March 30, 2017

**Re: ITW Middlesex School Cell Tower Application Filed 12-1-16**

**Figure 1.** United States Geological Survey of tree canopy height; see text for details. The area around the proposed tower (green color) is categorized as “Forest Height 10-25 meters.”

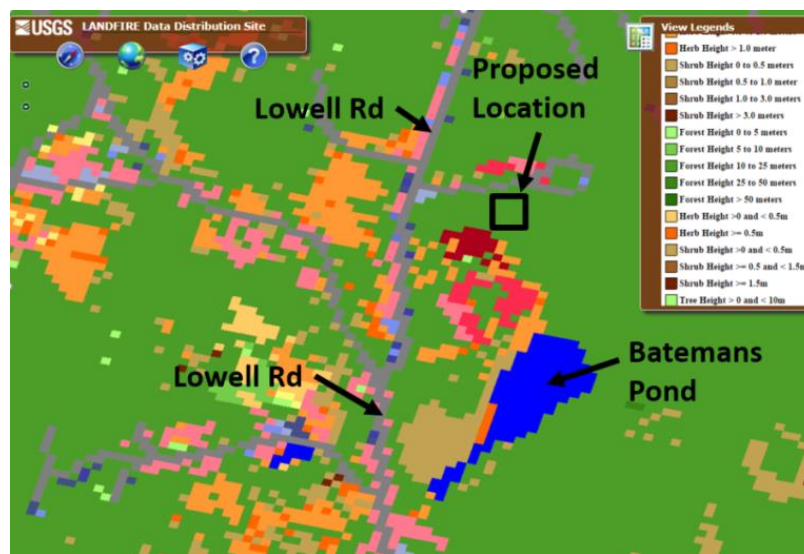
1. As shown in Figure 1 and Figure 2 below, the proposed 120-foot tall monopole tower **clearly exceeds** 20 feet above the average height of the existing tree canopy

within a 150-foot radius. Figure 1 is an excerpt of a high-resolution map from the United States Geological Survey of average tree canopy height.<sup>2</sup> Figure 1 indicates that the tree canopy height of the proposed site is in the category labeled as: “Forest Height 10-25 meters”, i.e. that the existing tree canopy in the area of interest is between approximately 33 feet and 82 feet. Figure 2, taken from applicant’s submitted crane/balloon test of December 30, 2016, confirms that the height of the proposed tower greatly exceeds 20 feet above the average height of the existing tree canopy.<sup>3</sup>

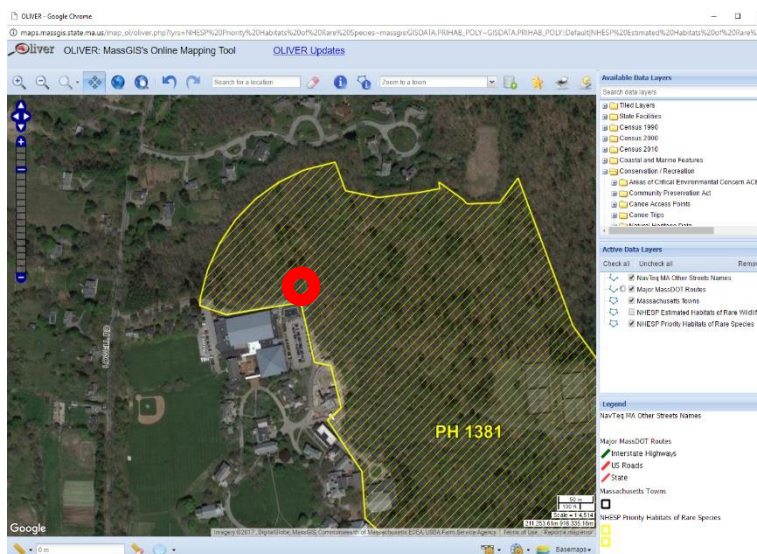
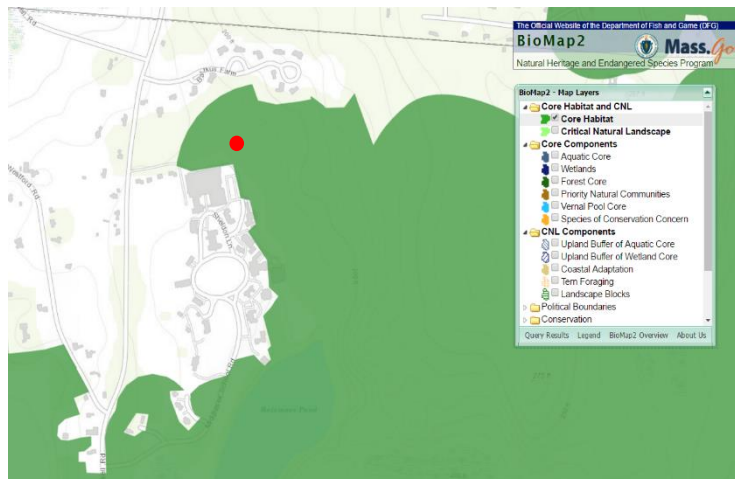
We have serious concerns regarding compliance with Section 7.8.4.2 (j)(vi), because the proposed site is clearly located in a designated priority habitat of rare species as listed by Massachusetts. Specifically, the proposed site is located in Priority Habitat No. PH-1381. (We are unclear why the Town Planner’s report of March 10, 2017 does not acknowledge this.) The map immediately below from Mass.Gov indicates PH-1381 in green color; proposed site is indicated by red circle.<sup>4</sup>
